SUNDRY NOTICES AND REPORTS ON WELLS

7. Farm or Lease Name: GILBERT DITCH UNIT

8. Well No.: 34-73 4-2H

☒ Other As Drilled Plat

Location:  
 GILBERT DITCH UNIT 34-73 4-2H  
 AS DRILLED LOCATION  
 1210' FNL & 1767' FEL  
 547' SOUTH & 220' EAST OF CENTER  
 LOT 2 (NW 1/4 NE 1/4) OF SECTION 4,  
 T 34 N - R 73 W, 6TH P.M.,  
 CONVERSE COUNTY, WYOMING

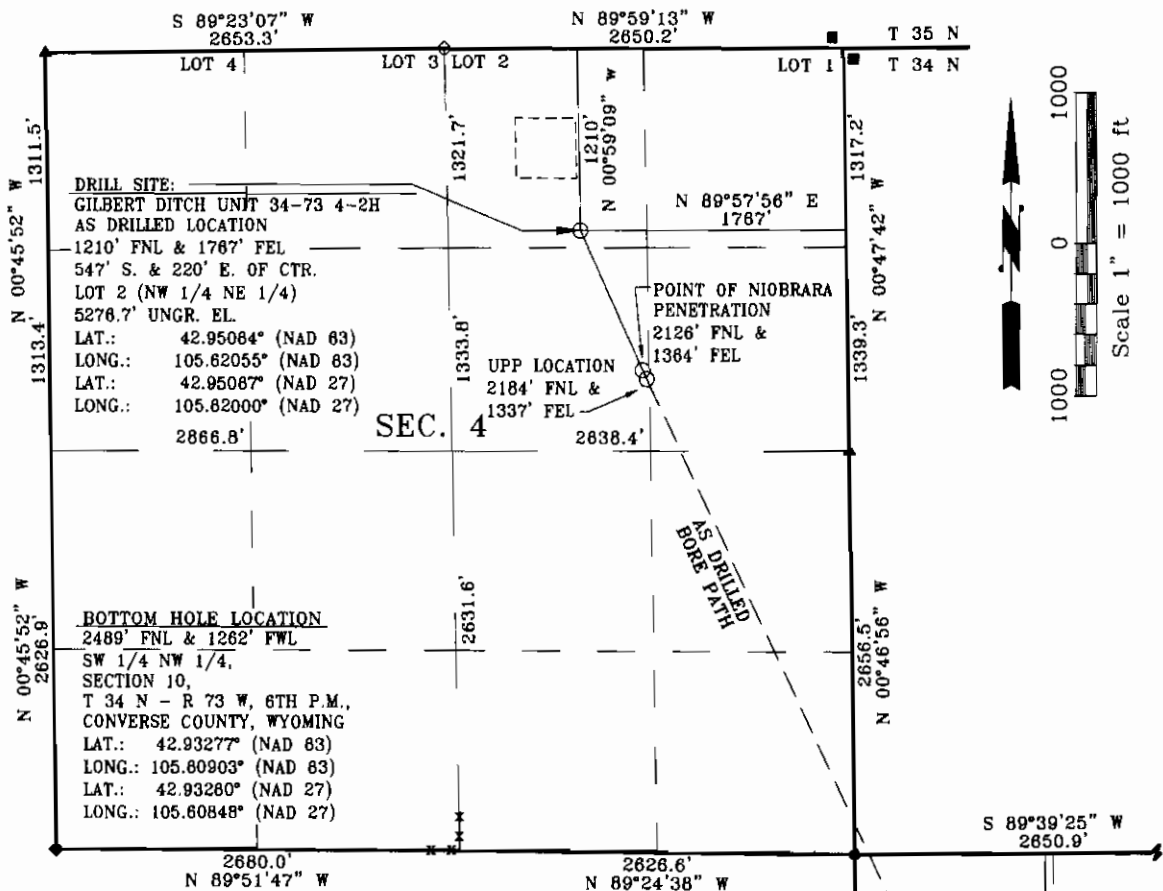
Please see the revised footages:

SHL: 1210 FNL & 1767' FEL Lot 2 NWNE Section 4-34N-73W  
42.95084; -105.62055

BHL: 2489' FNL & 1262' FWL SWNW Section 10-34N-73W  
42.93277; -105.60903
